**MODIFICATION SHEET NO. RDSO/2014/EL/MS/429, Rev. '0' Dated 26.02.14**

- 1.0 **Title:**  
Modification sheet for avoiding necessity of cab changing in case of failure of processor cards of VCU of WAG9/WAG9H three phase locomotives.

VCU Redundancy for WAG9 and WAG9H

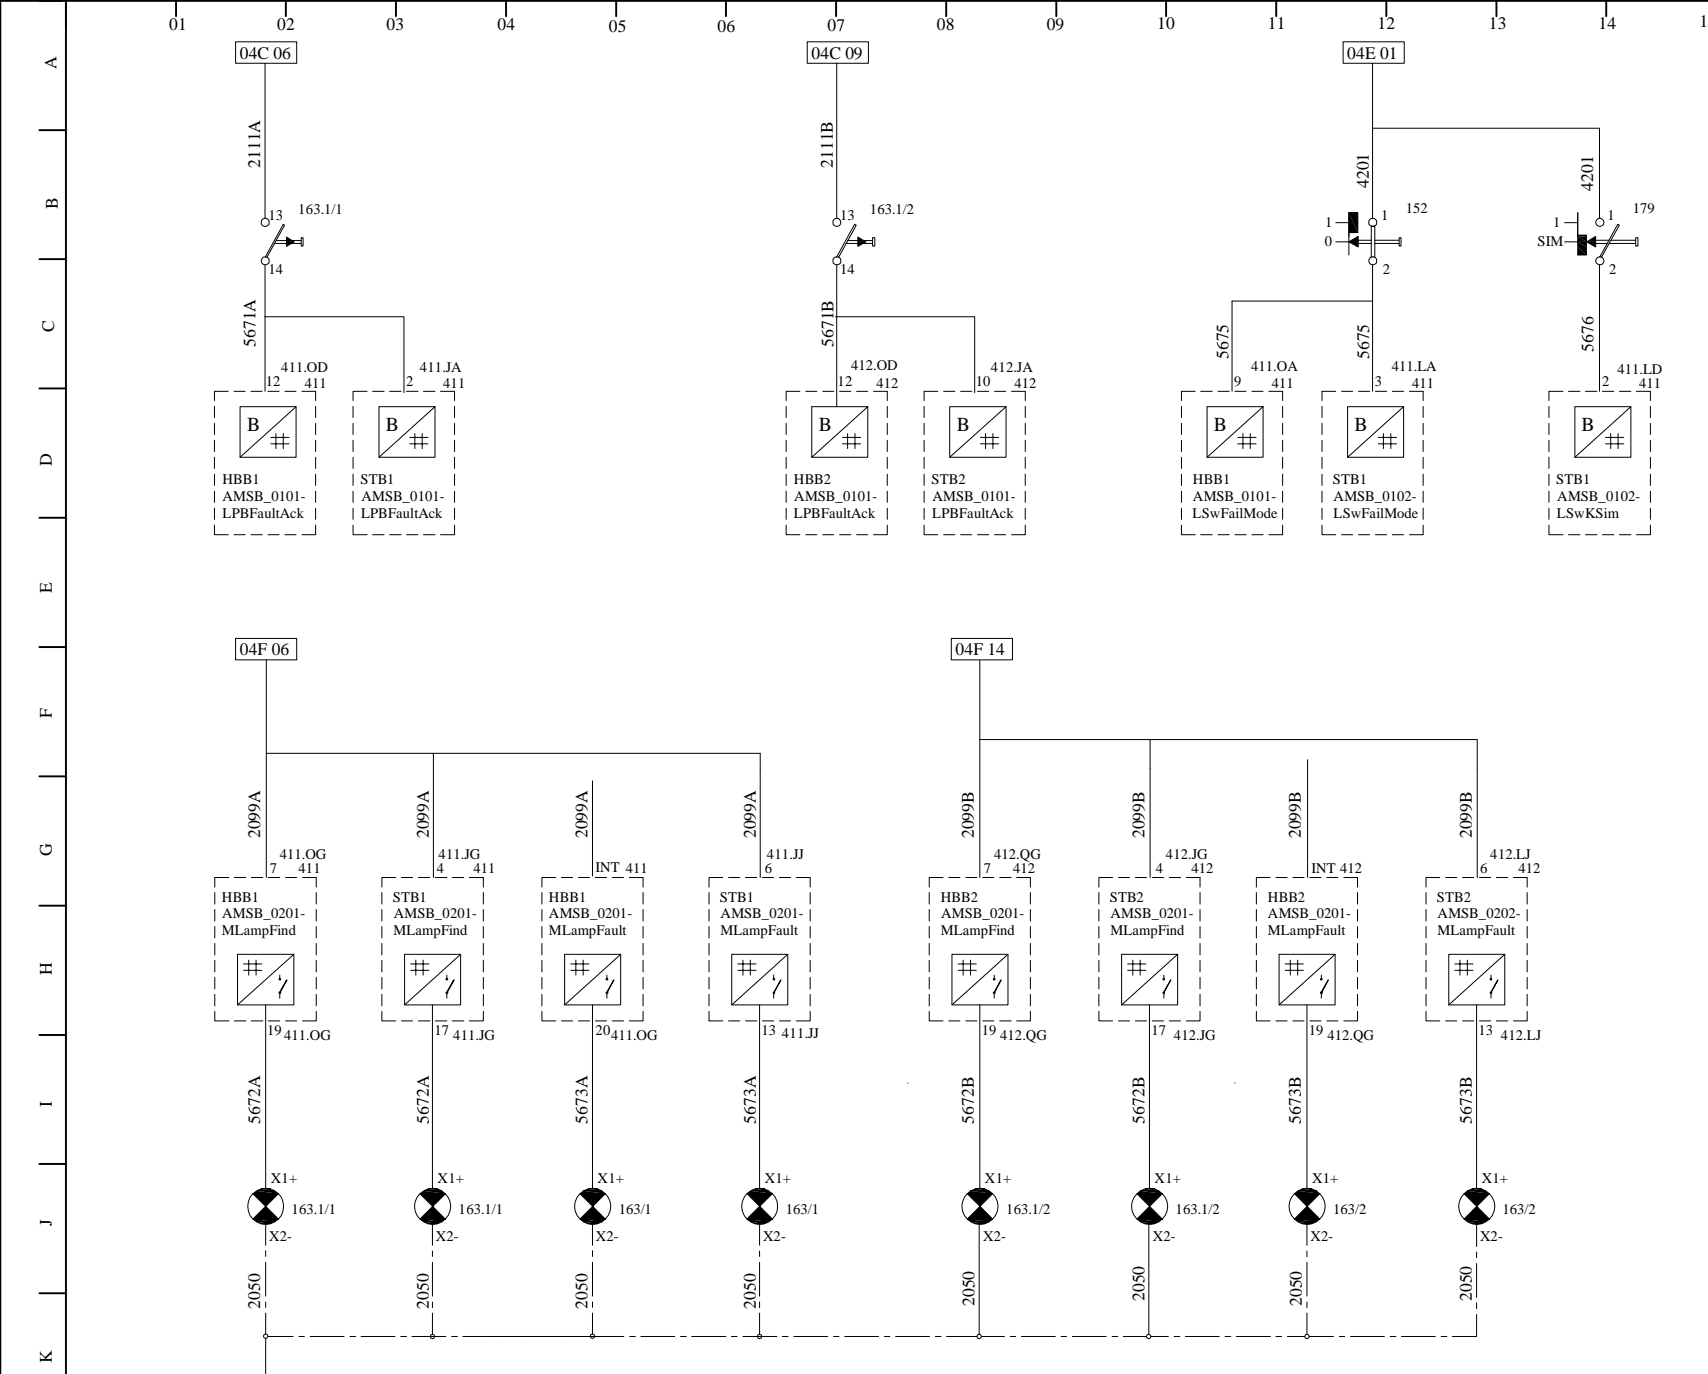
- 4.0 **Modified Arrangement to replace existing arrangement as given above in 3.0:**  
The modified arrangement of wiring for the input/output signals with related processors for WAG9/WAG9H is given in Annexure-I with red colour along with wiring details.

06E

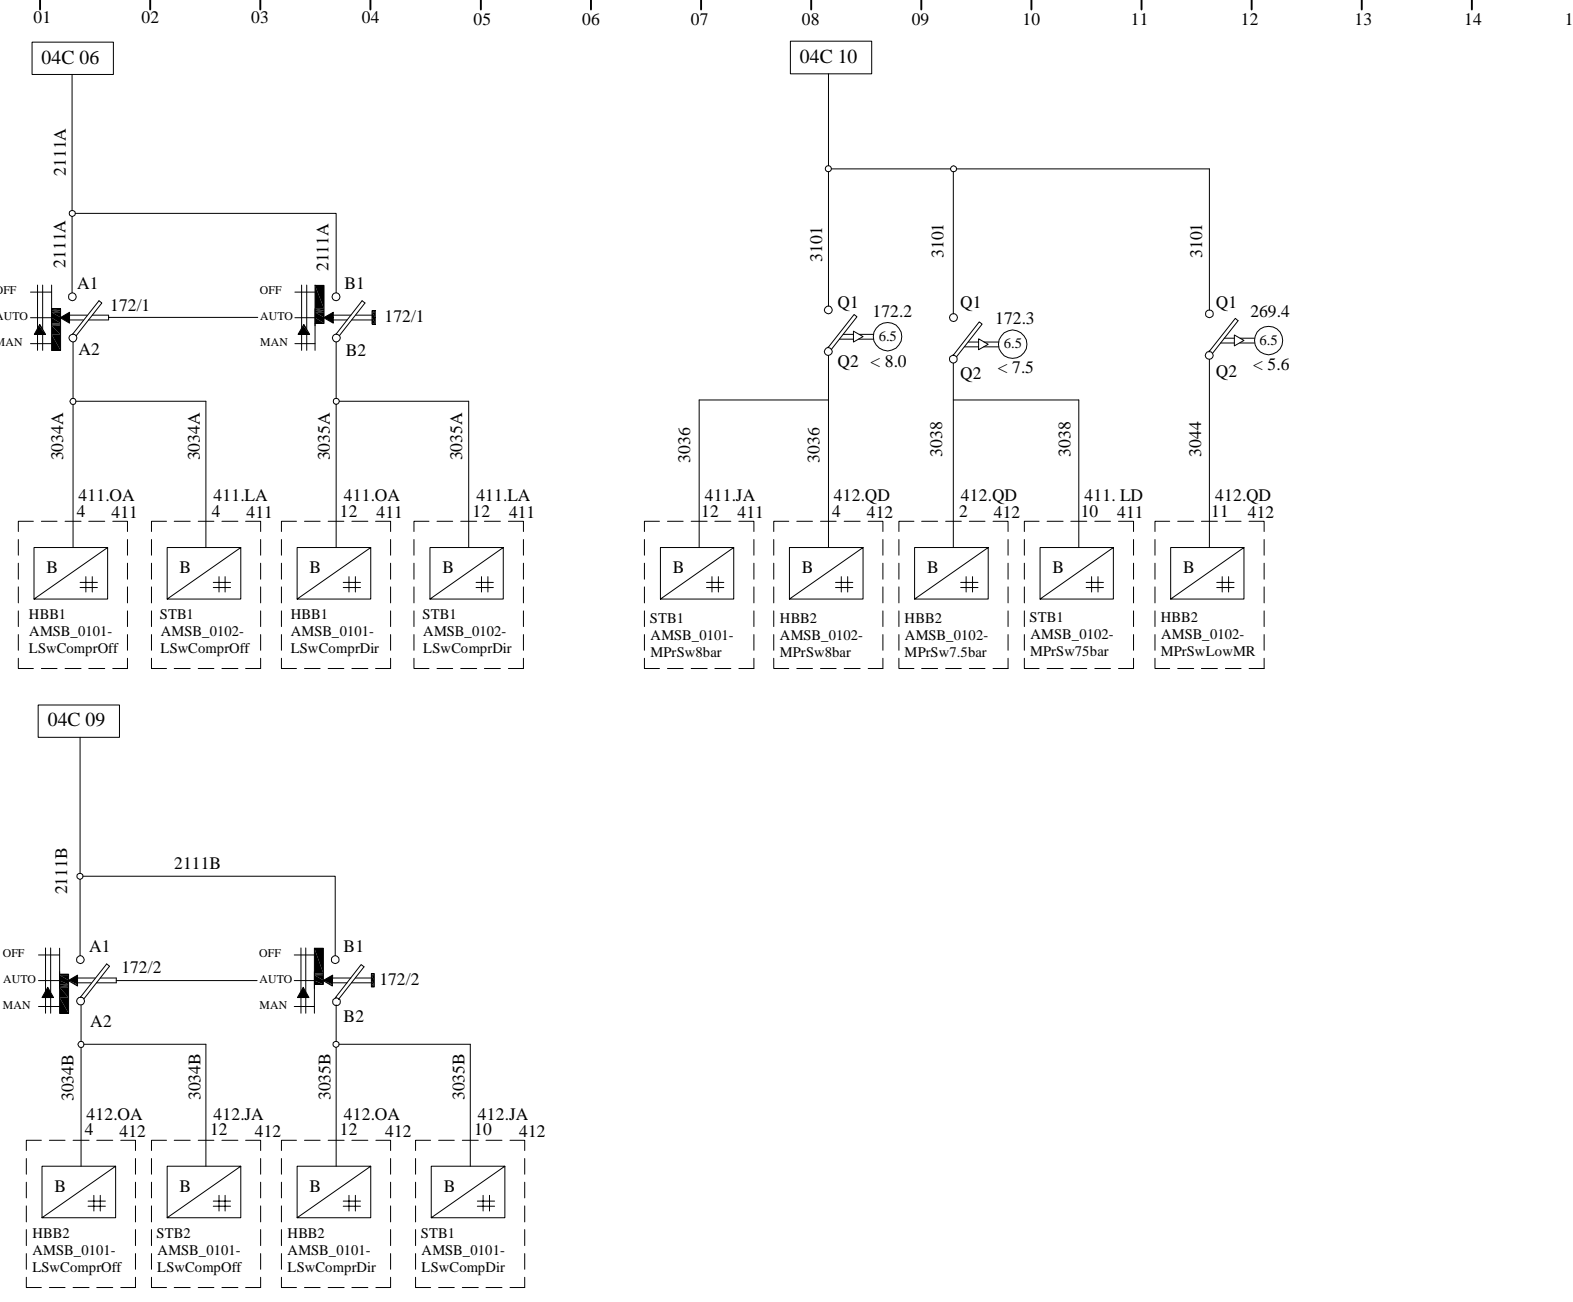
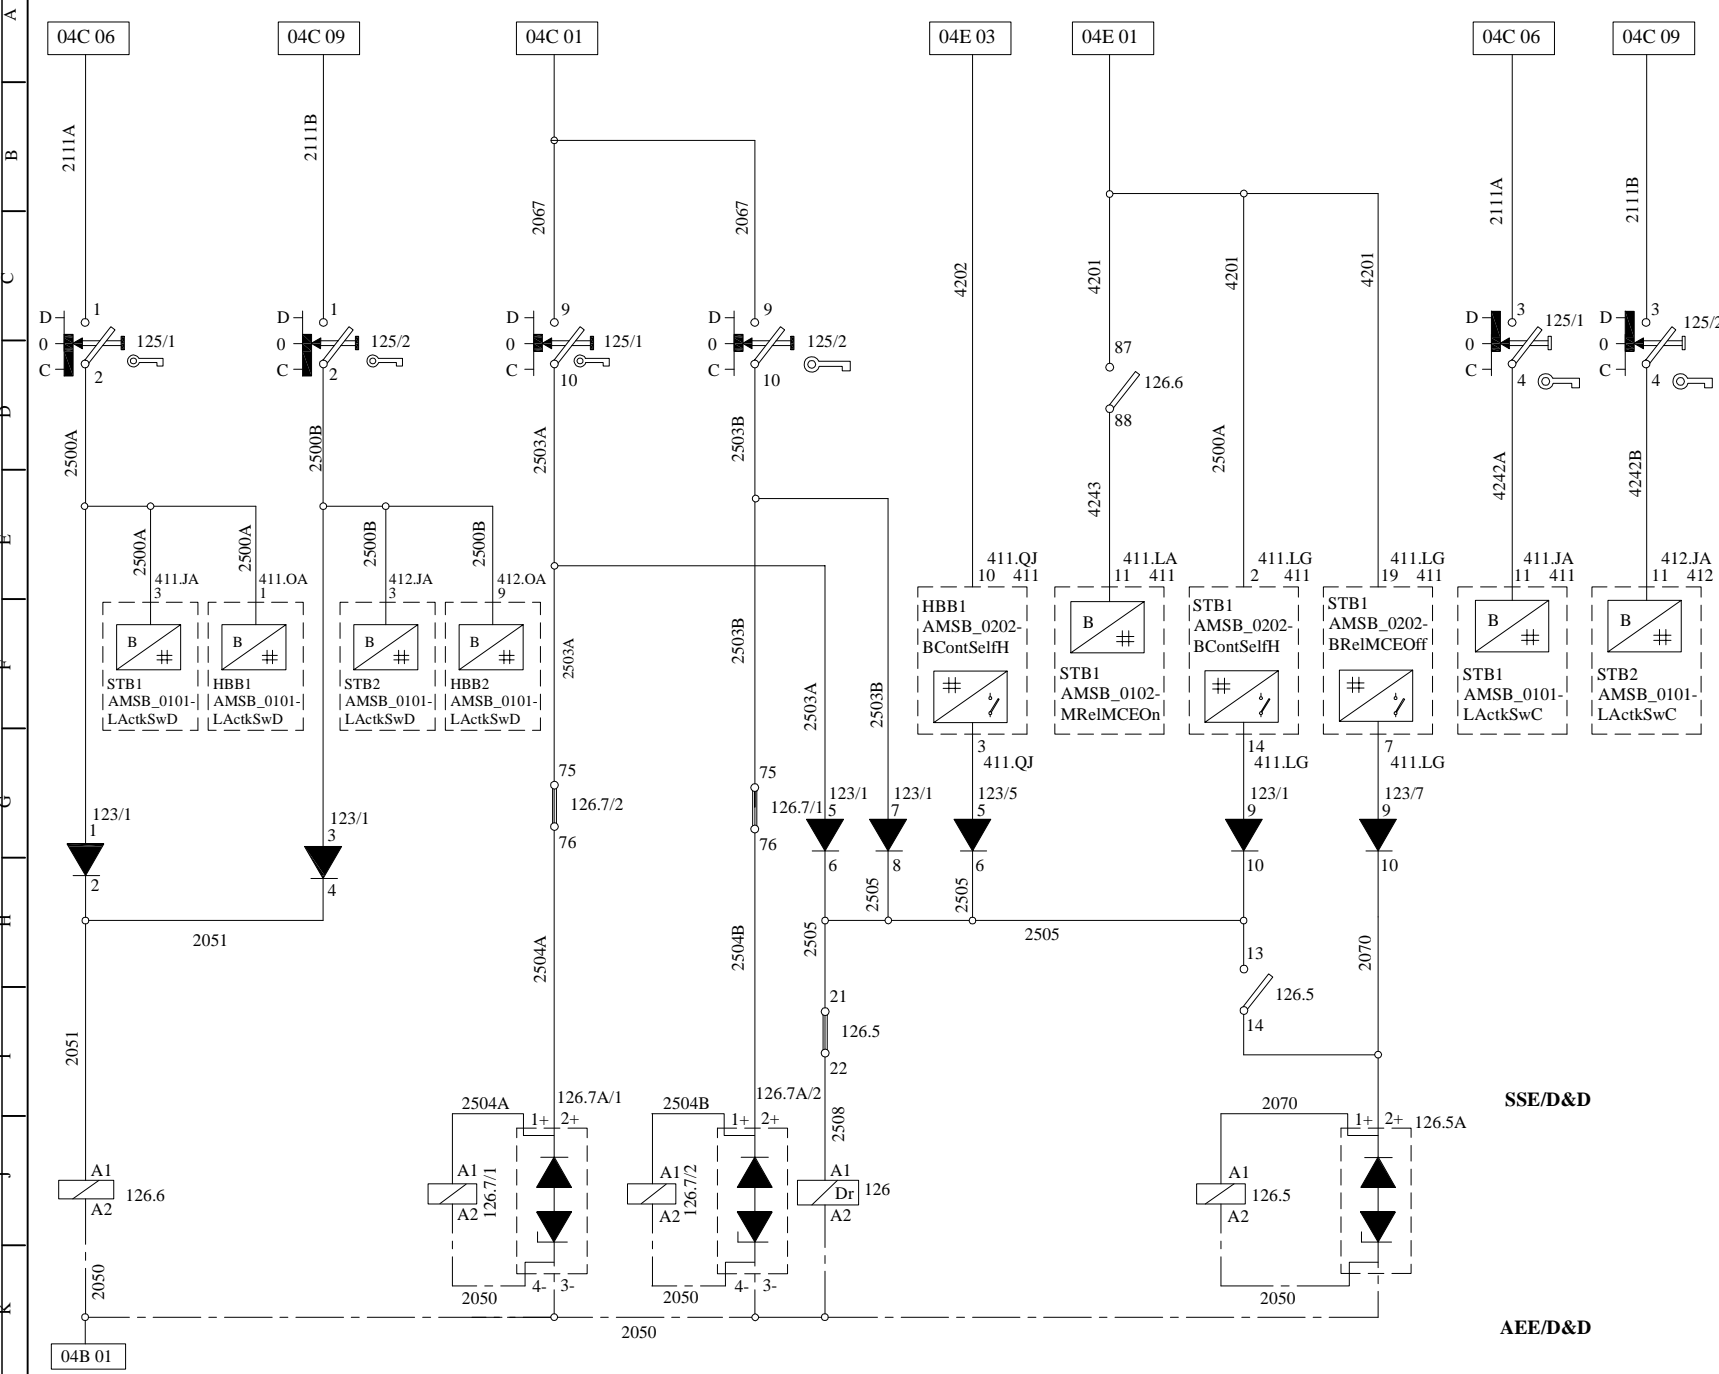
In addition to sheet no. 06E  
For MICAS based VCU redundancy to avoid Cab changing.

08C

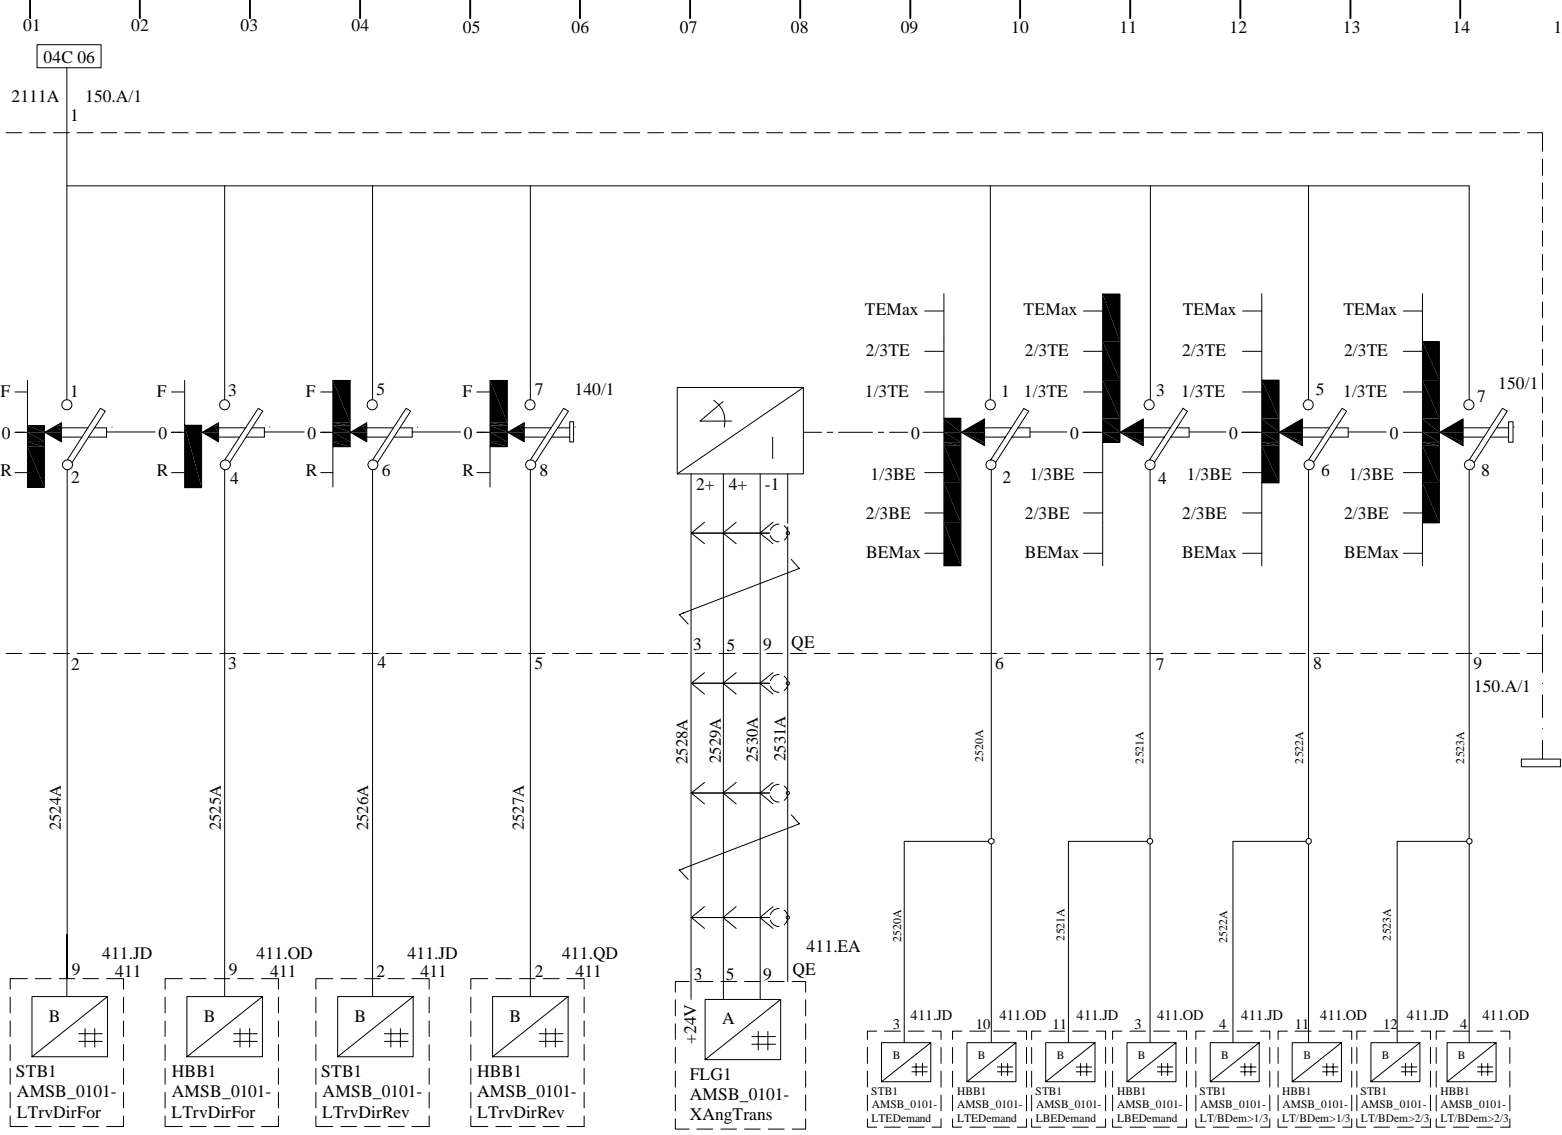
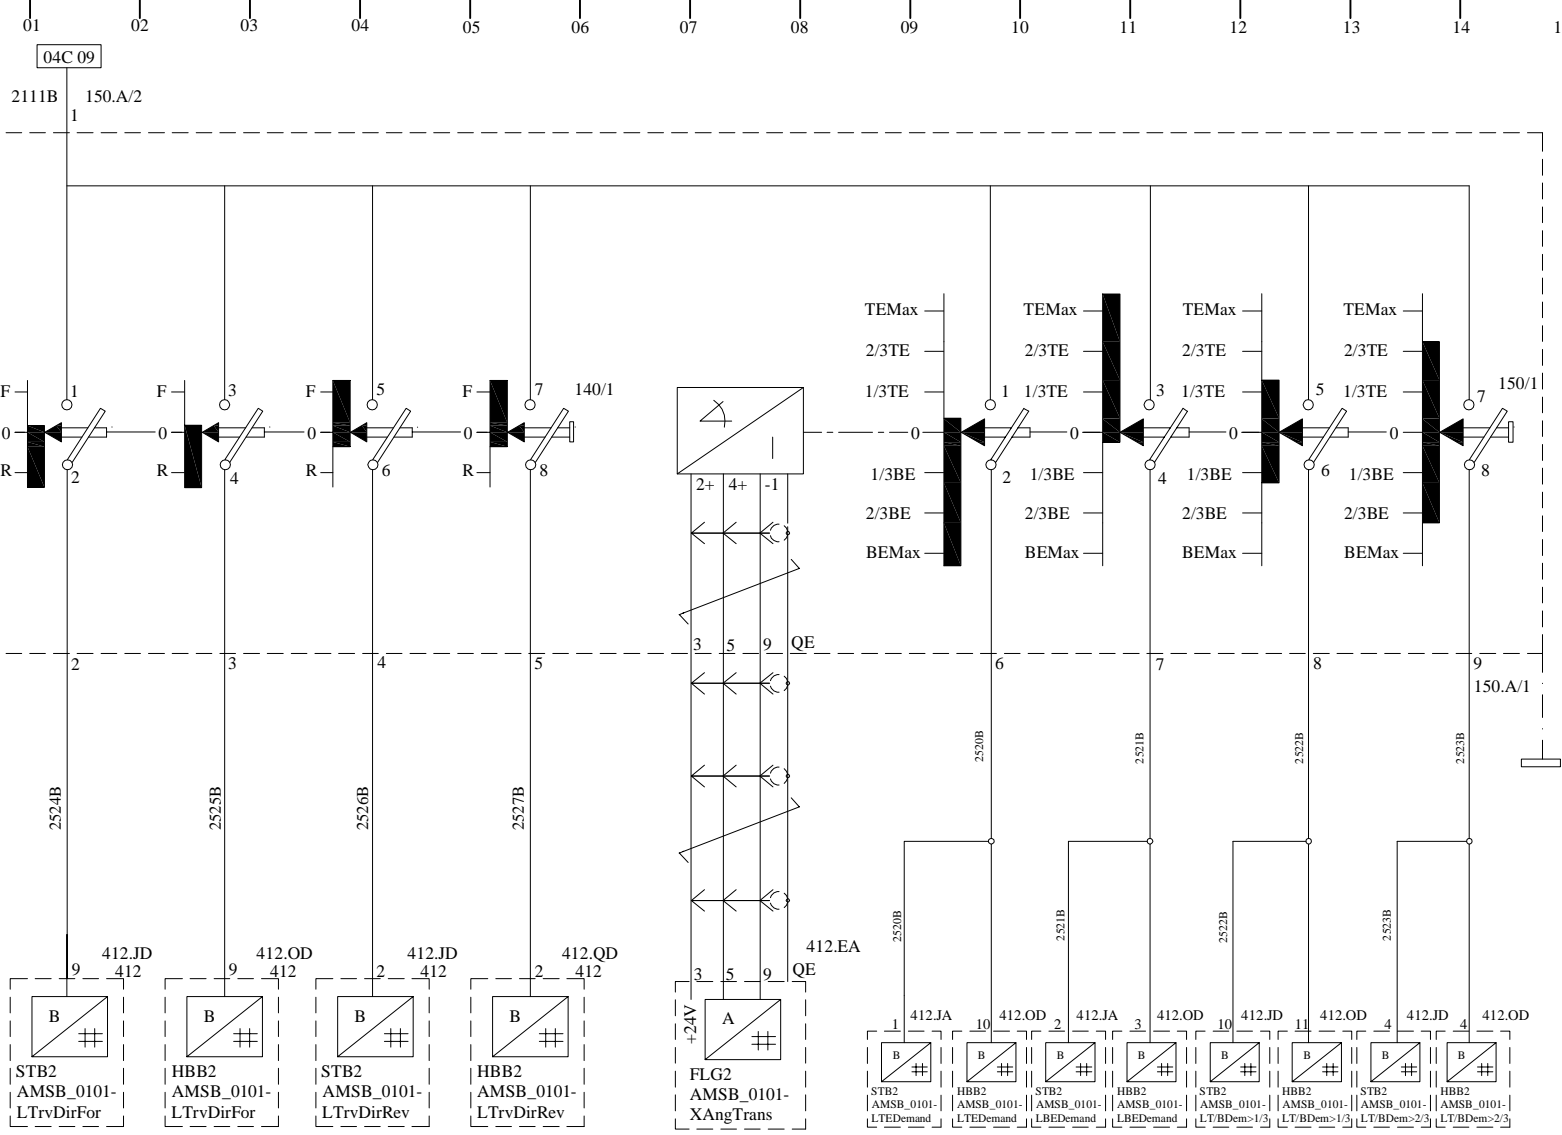
**MICAS based VCUs redundancy to aviod Cab changing**

MICAS based VCUs redundancy to avoid Cab changing
